Access Compliance Report Public Rights-of-Way (Curb Ramps)

Main Street: HUNTER_LN Cross Street: ELVIRA_AVE Location: NE

ADA ID: RPRK211005134746 Ramp Type: Type 1 - Perpendicular Diagonal Initial Pass/Fail: Fail Overall Compliance: No Severity Score: 16

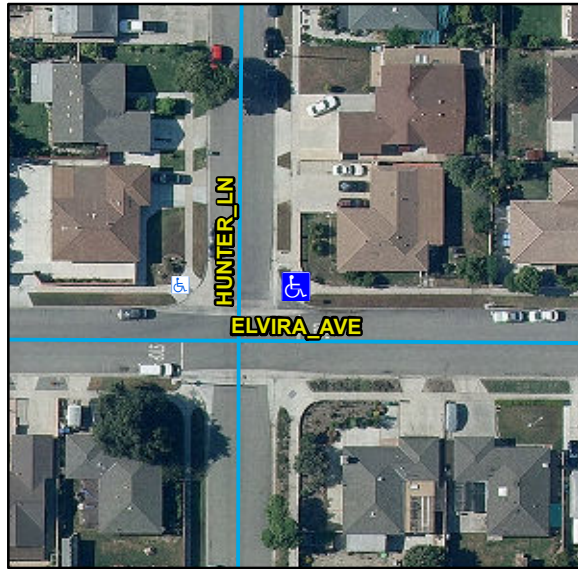
R304.2.2, R304.5.3, STD 1115

Compliance	Description	Data	Compliance	Description	Data
N/A	Ramp Length (in)	96	N/A	Flare Type LT	
Yes	Ramp Width (in)	48			N/A
No	Ramp Run Slope (%)	9.8	N/A	Flare Slope LT (%)	N/A
No	Ramp Cross Slope (%)	3.1	N/A	Flare Traversable LT	N/A
N/A	Landing Present	N/A	N/A	Flare Type RT	
N/A	Landing Length (in)	N/A			N/A
N/A	Landing Width (in)	N/A	N/A	Flare Slope RT (%)	N/A
N/A	Landing Run Slope (%)	N/A	N/A	Flare Traversable RT	N/A
N/A	Landing Cross Slope (%)	N/A	N/A	DWS Provided	N/A
N/A	Landing Movement Obstructed?	N/A	N/A	DWS Contrast	N/A
	Landing Movement Type	N/A	N/A	DWS Length (in)	N/A
N/A	Landing Shared	N/A	N/A	DWS Full Width	N/A
N/A	Clear Space	Yes	N/A	DWS Offset Left (in)	N/A
N/A	Clear Space To Crosswalk (in)	N/A	N/A	DWS Offset Right (in)	N/A
N/A	Marked Crosswalk 1	No	N/A	Marked Crosswalk 2	No
	Crossing 1 Direction	W		Crossing 2 Direction	S
	Marked Crosswalk 1 Width (in)	N/A		Marked Crosswalk 2 Width (in)	N/A

N/A	Ramp Inside Crosswalk 1	N/A	Yes	Ramp Inside Crosswalk 2	N/A
	Crossing 1 Slope (%)	7.4		Crossing 2 Slope (%)	0.9
	Crossing 1 Cross Slope (%)	2.2		Crossing 2 Cross Slope (%)	1.1
N/A	Gutter Ponding	N/A	No	Curb Slope	11.1
Yes	Gutter Lip Height (in)	0		Road Run Slope (%)	3.3
N/A	Gutter Run Slope (%)	N/A		Road Cross Slope (%)	3
N/A	Gutter Cross Slope (%)	N/A			
Yes	Overall Surface Condition: Acceptable		Yes	Perp Joint Present	Yes
	Cross Gutter Present?	Yes		Spandrel Present?	Yes
	Replace Cross Gutter?	No		Replace Spandrel?	No

Remove & Replace Curb Ramp With Two New Directional Ramps or Equivalent.
